SUMMARY OF CONCERNS IN RELATION TO THE PROPOSED NORTHCONNEX TUNNEL

This is an objection to many aspects of the proposed NorthConnex tunnel.

SECTION A: THE CONNECTIVITY OF NORTHCONNEX SOUTHERN VENTILATION FACILITY AT THE SOUTHERN INTERCHANGE, THE SOUTHBOUND TUNNEL IN PARTICULAR

MOTORWAY OPERATIONS COMPLEX - SOUTHERN VENTILATION FACILITY - SECTIONS
M1-M2-5000-DR-JD-0525

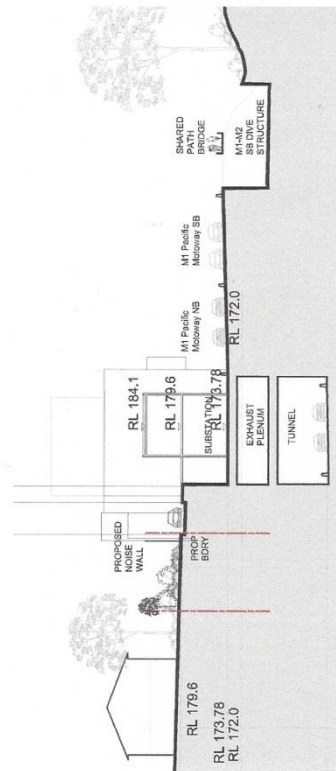
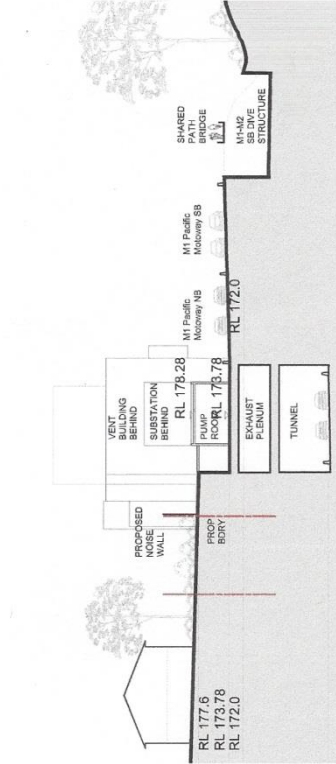
5. *EIS Volume 4, Technical working papers - Urban Design, 6.0 Operational Ancillary Facilities*
EIS Page 99 there is the diagram "Motorway Operations Complex – Southern Ventilation Facility – sections. *Page 10 below* The diagram has the cryptic label "Connection to tunnel TBC". What does TBC stand for? To be considered? Why is tunnel singular? Which tunnel is the diagram referring to northbound or southbound? There is no diagram showing any connection from the Southern Interchange ventilation facility to either the northbound or the southbound tunnel in any way AND YET

- Diagrams need to be provided showing the inter-relation between the shaft, the ventilation outlet and the motorway operations centre with a clear description of what is to be constructed and how it will operate.
- The community needs irrefutable evidence that the polluted air from the southbound tunnel exit portals will not be allowed to flow like an invisible sewer through West Pennant Hills, North Rocks, Carlingford and Beecroft.

NORTHERN VENTILATION FACILITY - CROSS SECTIONS

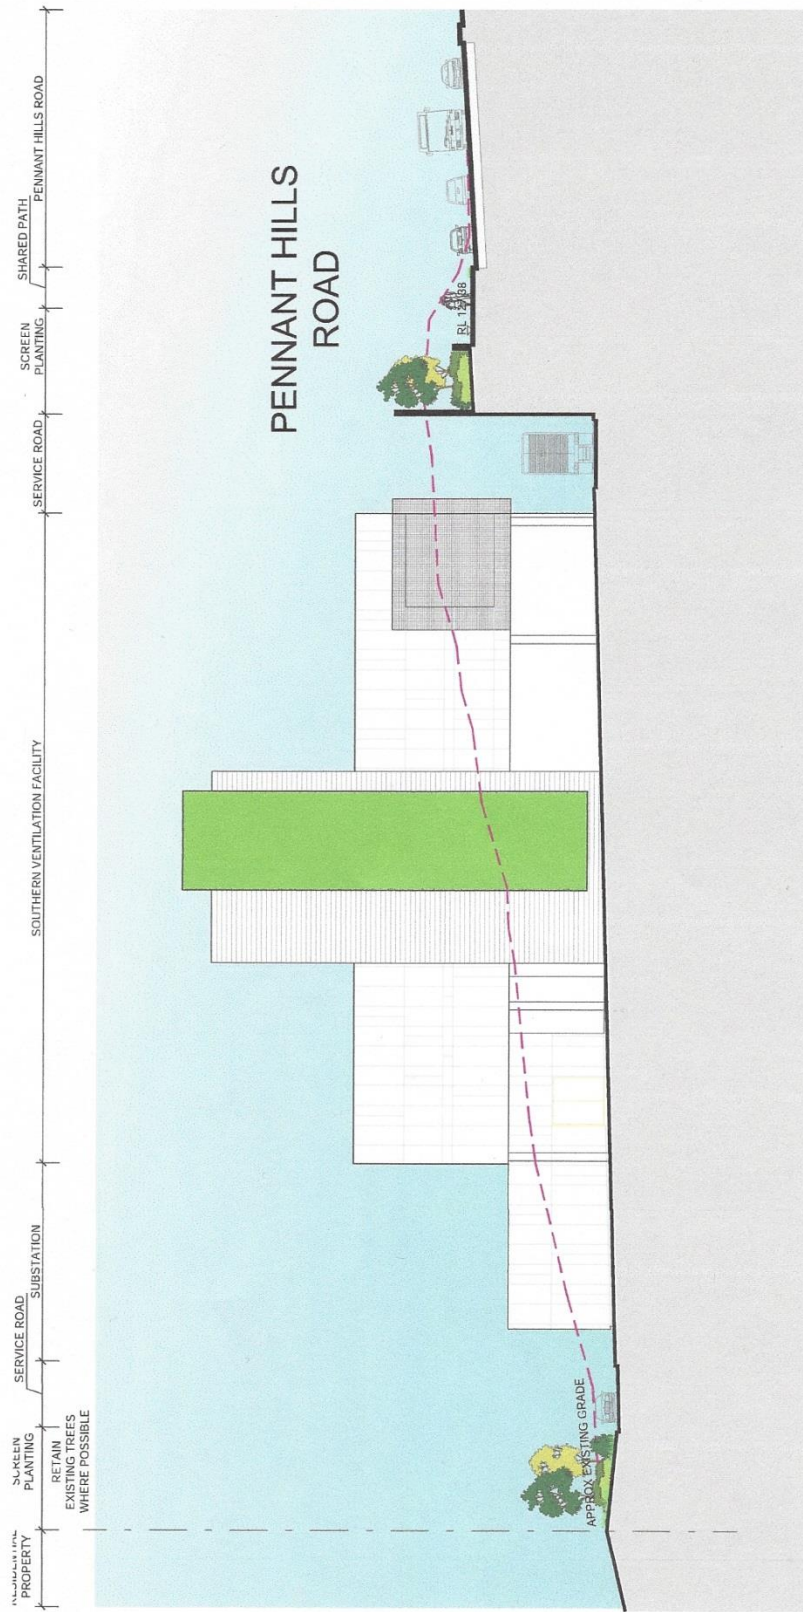
EIS page 135 *Page 11 below* there is a very explicit diagram showing the *Northern Ventilation Facility – cross section*.

Why are there no comparable diagrams for the Southern Interchange and the Southern Ventilation facility?

M1-M2-5000-DR-UD-0556
NORTHERN VENTILATION FACILITY - LONG SECTION

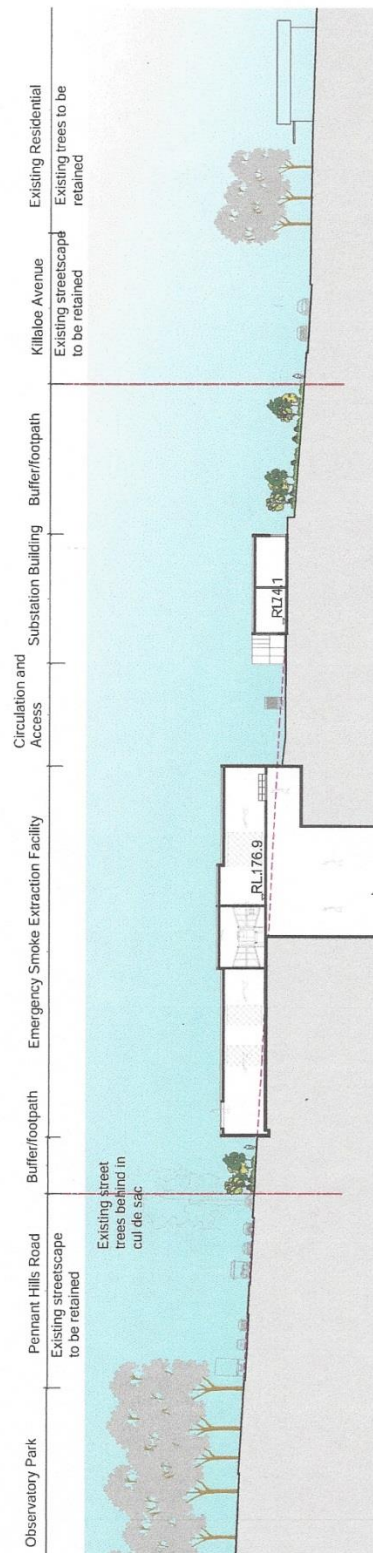
EIS page 134 *Page 12 below* there is a very explicit diagram showing the *Northern Ventilation Facility – long section*.
